Docket Item # 2
BAR CASE #2011-0246

BAR Meeting
September 21, 2011

ISSUE: Alterations (signage, awnings, air intake louver/air vent openings)

LOCATION: 277 S Washington Street

Figure 1: Existing east façade.

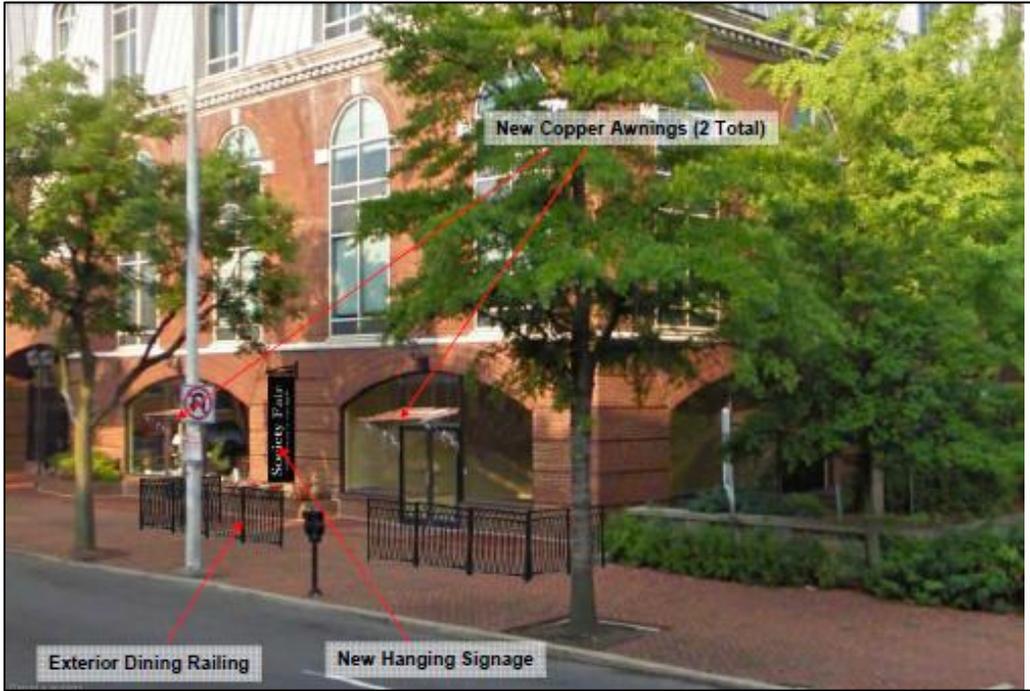
The proposed air intake louver and air vents are to be located near the middle of the block on a secondary wall elevation. The three air vents will each measure less than one square foot: two 8" exhaust flues with caps being used for the bread oven and 1 12" exhaust flues with cap for the hot water heater. The air intake louver measures 3'x6'. The applicant proposes to paint all 4 openings to match the existing brick. While the applicant is installing four new openings on the building, Staff supports the installation since they will be located on a secondary wall elevation. Staff also feels that they will be minimally visible due to the scale and massing of the building.

1. That the scroll bracket is installed in the mortar, and not the brick;
2. That the sign is reduced by 5 square feet, measuring approximately 2'-6" x 5'-0";
3. That the final design of the metal scroll in the transoms above the doors is approved by Staff;
4. That the new air intake louver and air vents are painted to match the adjacent wall surface.

Figure 5: Proposed sign plan.

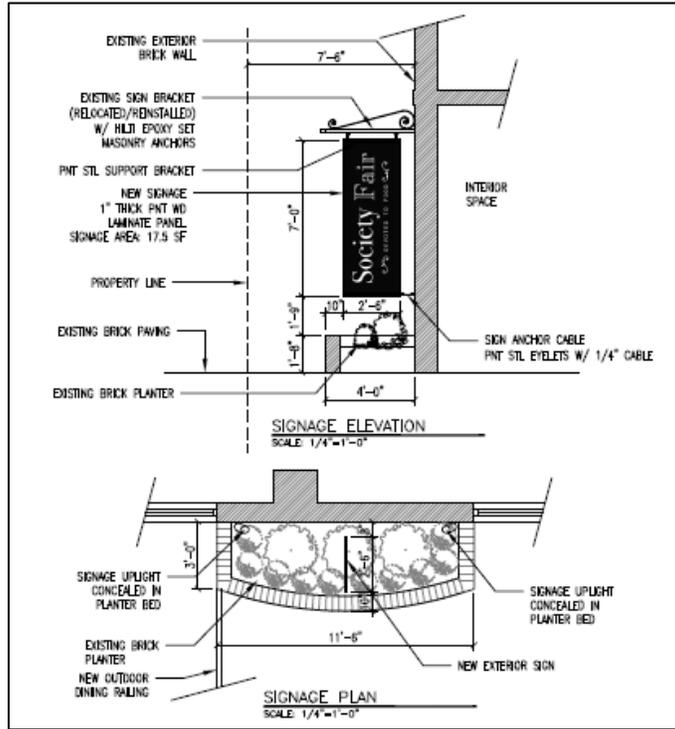
The applicant is proposing one 2'-6"x7' wood, double-sided hanging sign (17.5 square feet) with the words "Society Fair Devoted to Food" installed on the S Washington Street façade. They intend to reuse the existing metal scroll bracket.

The *Criteria & Standards for Administrative Approval for Signs within the Historic Districts* states that “a one-piece double-sided hanging sign” can have “a maximum square footage of 7 square feet.” While the Board has the authority to approve a larger hanging sign, Staff feels that the proposed 2’6”x7’0” hanging sign (17.5 square feet) is too large, even for this enormous building, and that approval of this large of a sign would set a difficult precedent for other buildings along Washington Street. Staff recommends reducing the proposed signage by 5 square feet to make the sign 2’-6”x5’0” (12.5 square feet). While many would still consider this to be too large, it is important to take the extreme mass of the property into consideration. The Atrium Building appears to be 3 stories to the untrained eye, when it is in fact, 5 stories tall. It also encompasses half of an entire city block. While Staff and the Board encourage signs to target pedestrians more than automobiles, the expansive nature of Washington Street and the wide sidewalk, combined with the massing of the Atrium Building, encourage the use of a larger sign at this particular site.

The frontage of this space is 67’ which would allow the BAR to approve the proposed 17.5 square feet of signage as the zoning ordinance allows the BAR to approve one square foot of sign for every linear foot of frontage. However, it is important to note that most signs in the historic district are not as large, or as numerous, as the maximum allowed under the Zoning Ordinance. The typical square footage of hanging signs within the historic district is 7 square feet.
